PERMIT

SEWAGE DISPOSAL SYSTEM
HOWARD COUNTY HEALTH DEPARTMENT
BUREAU OF ENVIRONMENTAL HEALTH
410-313-2640

UBDIVISION Monticello LOT NUMBER 25 ADDRESS 1733 Oakdale Drive

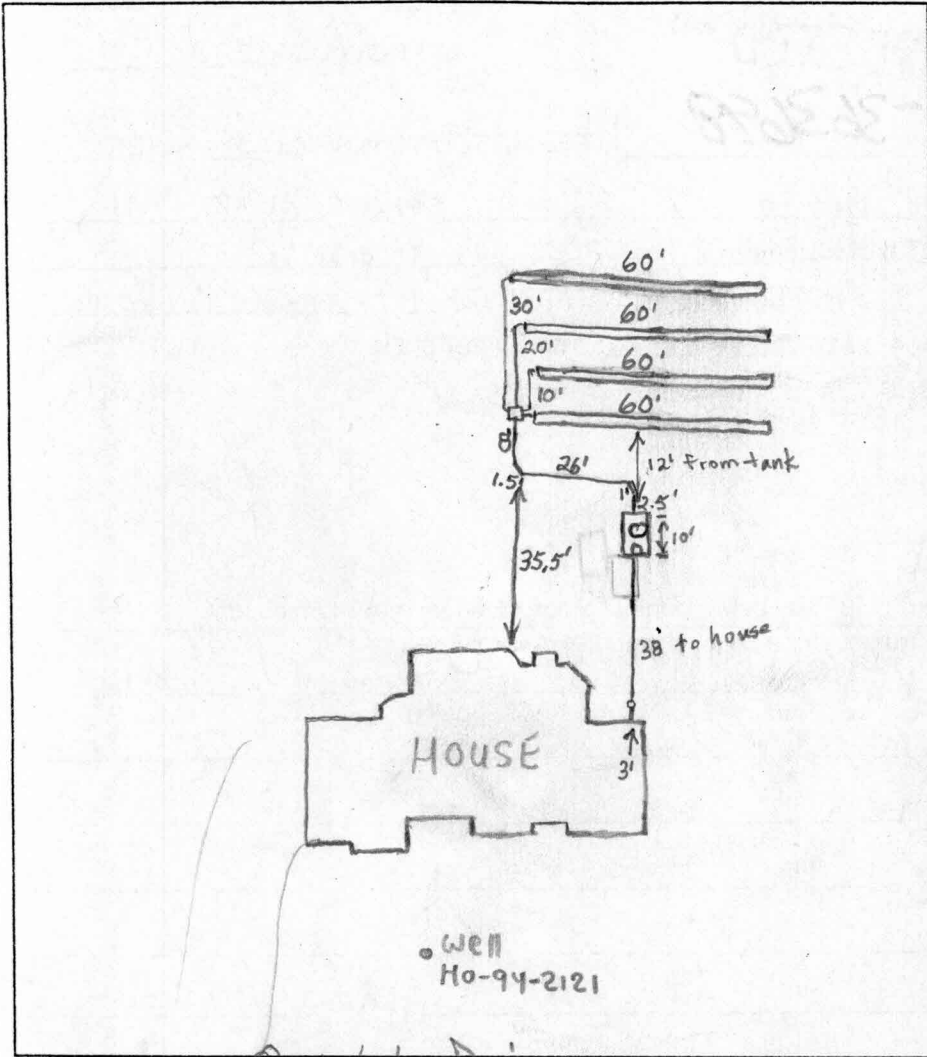
PRE-CONSTRUCTION INSPECTION: 6/8/01 Easement not staked. Builder notified (BB)

6/21/01 - OK TO RUN 4 - 60' TRENCHES TOWARDS RIGHT LOT LINE (SRK)

INSPECTION COMMENTS: 6/21/01 - TANKS SET (SRK) 6/22/01 O.K. to cover. Need

house connection. (BB) 8/31/01 - HOUSE CONNECTION VERIFIED TO HAVE BEEN

MADE BY BUILDER (SRK)
